HAMMOND REEF GOLD PROJECT RESPONSE TO COMMENTS ON FINAL EIS/EA

COMMENT – T(3)-02

Source: Canadian Environmental Assessment Agency

FIGURE: 2-17

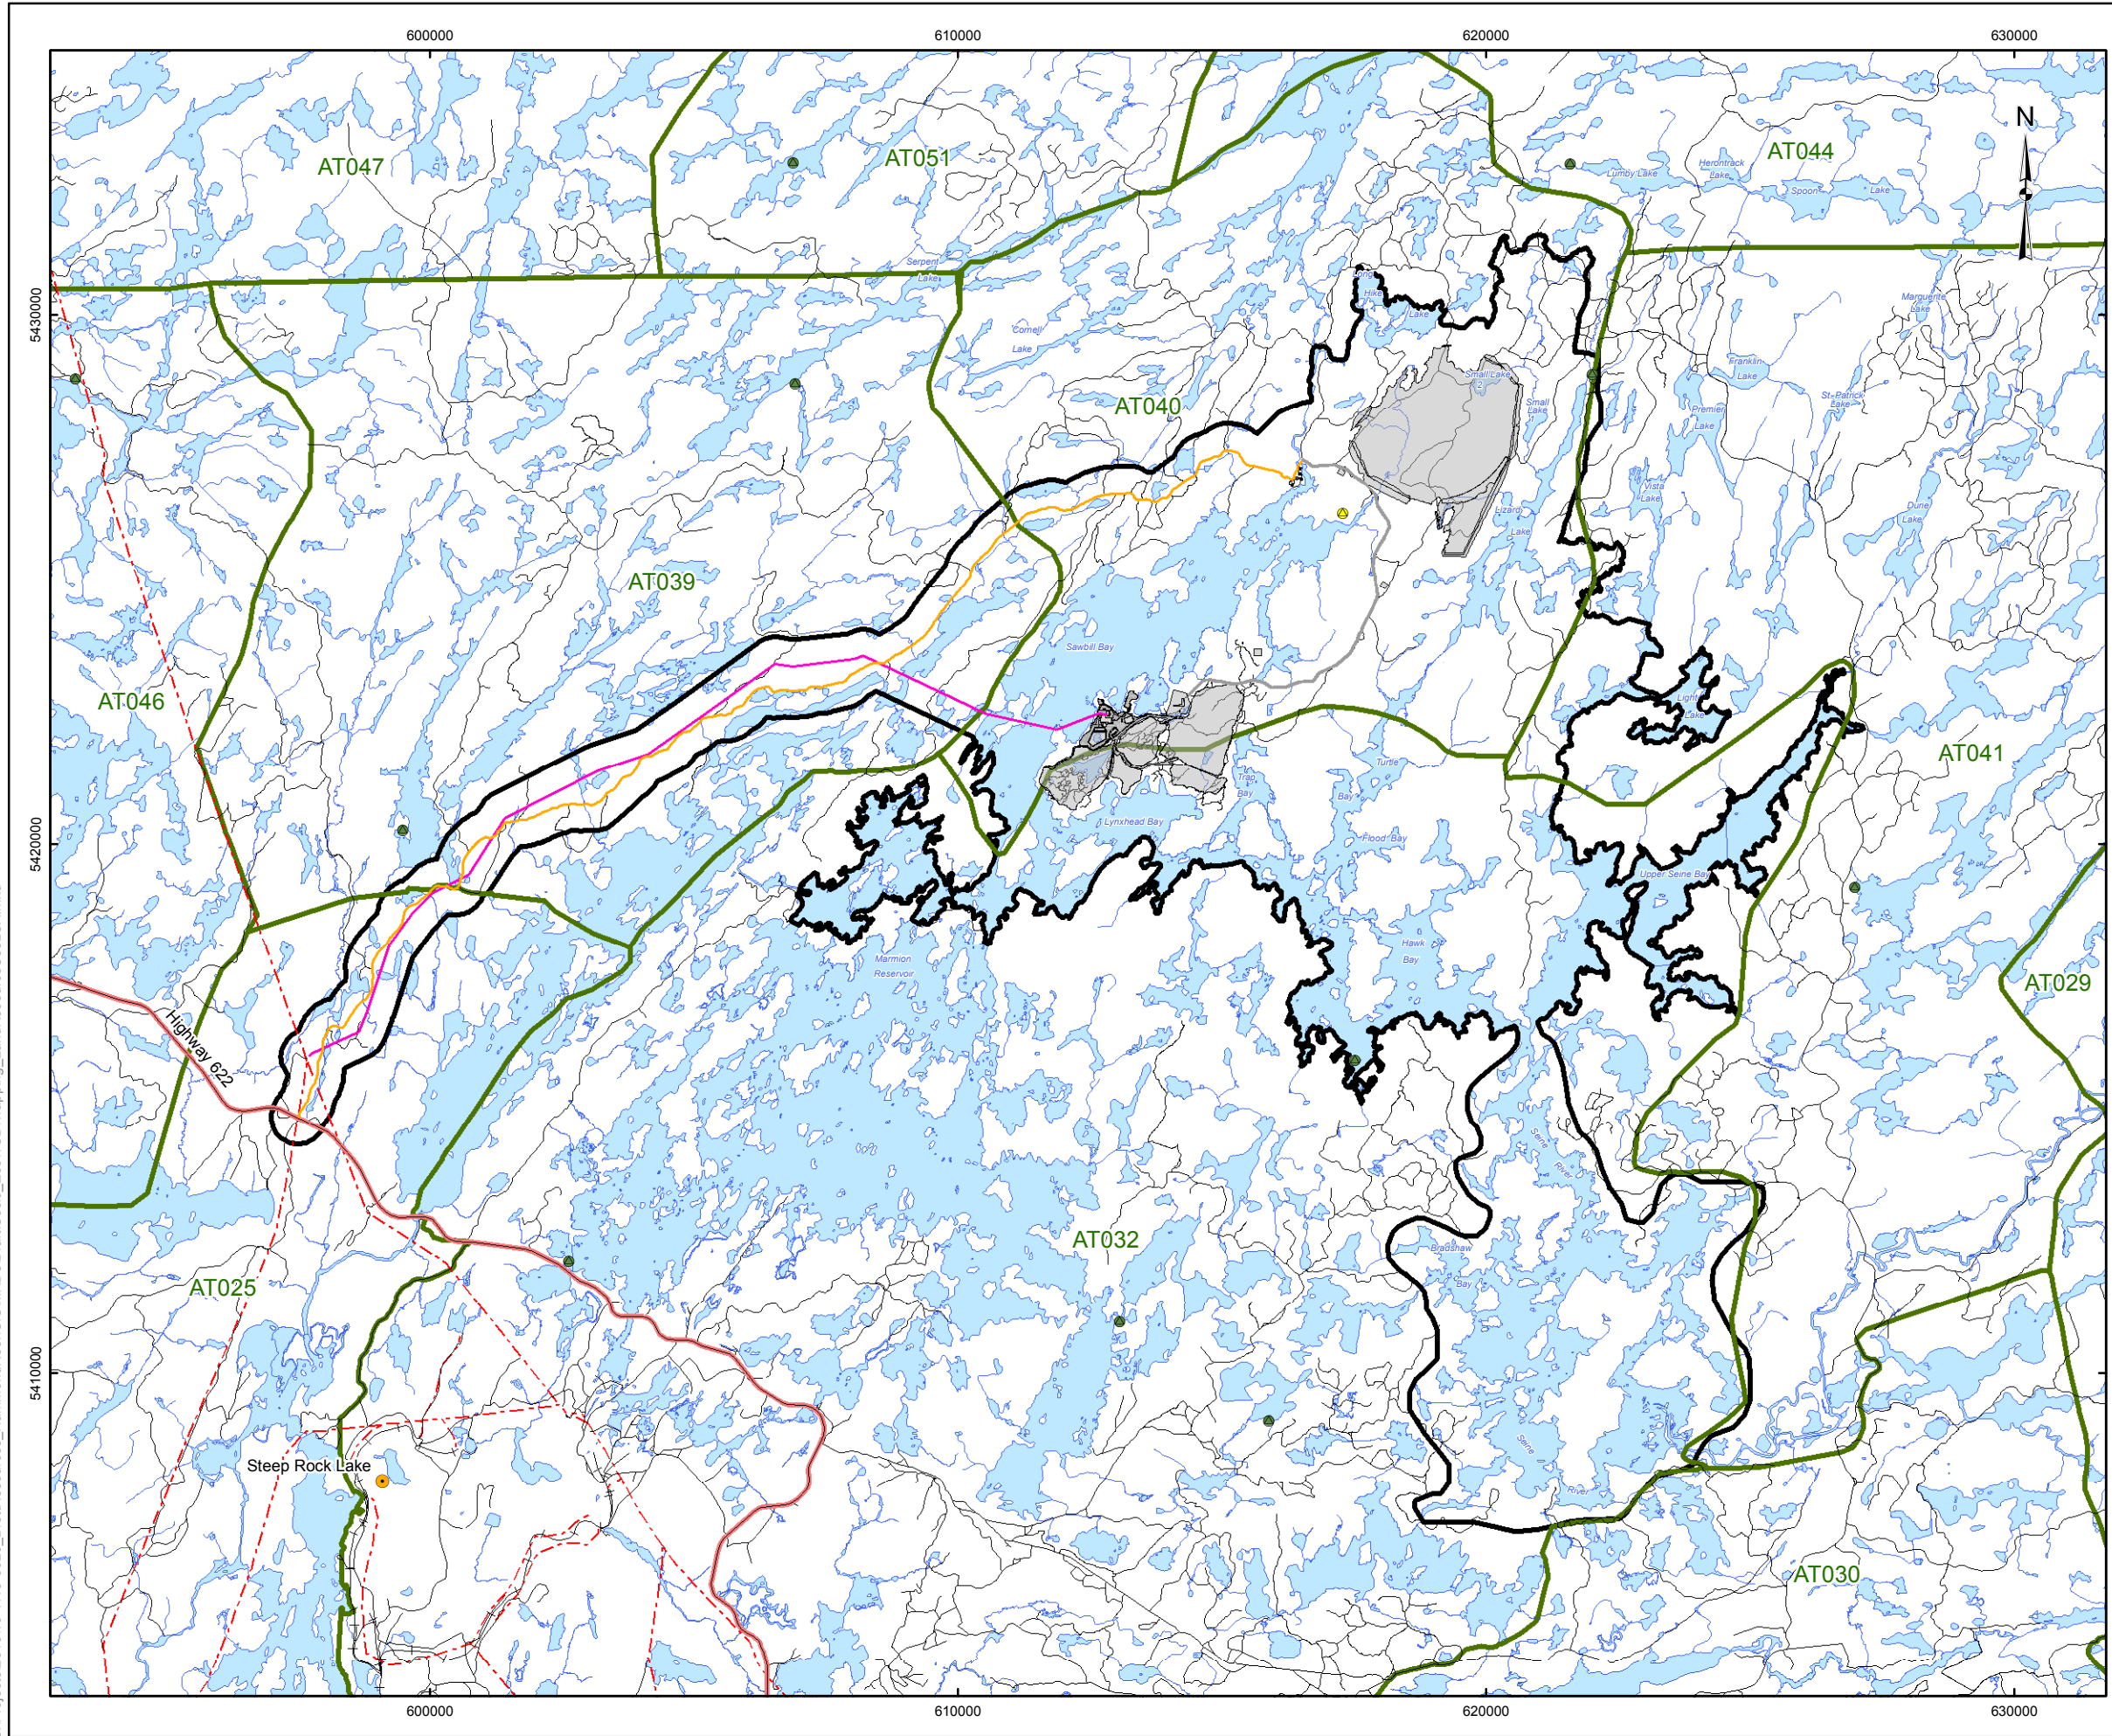
Subsection 2.2.7.3 of the Socio-Economic TSD indicates there are six trapline areas within the study areas. Subsection 3.3.1.9.1 lists four trapline areas will be affected by the removal of 2063 hectares of land that would otherwise be available for trapping. Section 8 of the Aboriginal Interests TSD indicates that there are agreements with trapline holders for three trapline areas affected by the removal of land base in the local study area. It is unclear if mitigation or accommodation measures have been proposed for the other trapline areas within the study areas where no formal agreement is held with the trapline holder.

Information Request T(3)-02 requested consideration of effects that would include the extent to which traplines would be completely or partially lost. The response provides a description of the adverse effects on the traplines, however does not include the extent to which the traplines will be lost. Further, it is stated that agreements are in place with the trapline holders that will be directly affected by the Project; however it is not clear if the trapline holders are members of the Indigenous groups potentially affected by the Project. Section 8 of the Aboriginal Interest Technical Supporting Document indicates that there are three agreements in place, however the response to Information Request T93)-02 suggests there are two agreements.

- a) Clarify the extent to which traplines would be completely or partially lost (i.e. estimated area size) due to the project.
- b) Clarify the number of agreements that are in place.
- c) Clarify whether the agreements that are in place, or will be, for any trapline holders that are members of the Indigenous groups potentially affected by the Project.
- d) Clarify whether the agreements apply to or affect non-Indigenous trapline holders.

The Agency understands from the response that CMC has an agreement in place with the registered licence holder for trapline area 040, a member of Lac des Mille Lacs First Nation. The Agency also understands from information within the Aboriginal Interests Technical Support Document that a band member of Seine River First Nation has a trapline in the LSA. This discrepancy requires clarification.

- a) Explain the discrepancy between the information about which Indigenous groups have traplines in the LSA.
- b) Provide the information (location, project effects on the practice and experience of trapping, as well as mitigation for effects on trapping) for those Indigenous groups, other than Lac des Mille Lacs First Nation, whose members have traplines in the LSA.

In response to comment T(3)-02, the potential effects on the trapline areas identified in the Socio-Economic TSD are described and assessed in more detail the following tables. Figure 2-17 from the Socio-Economic TSD shows the location of the trapline areas and is attached for convenience.

Areas of traplines AT040 and AT032 will be temporarily partially lost during the active phases of the project (i.e., construction, operation and closure). The estimated area of partially lost trapline are:

AT040: 1705 ha

AT032: 358 ha

The holder of trapline area AT040 is a member of the Seine River First Nation. The holder of trapline area AT041 is a member of Lac des Mille Lacs First Nation. There are no other Aboriginal trapline holders within the Air Quality Local Study Area.
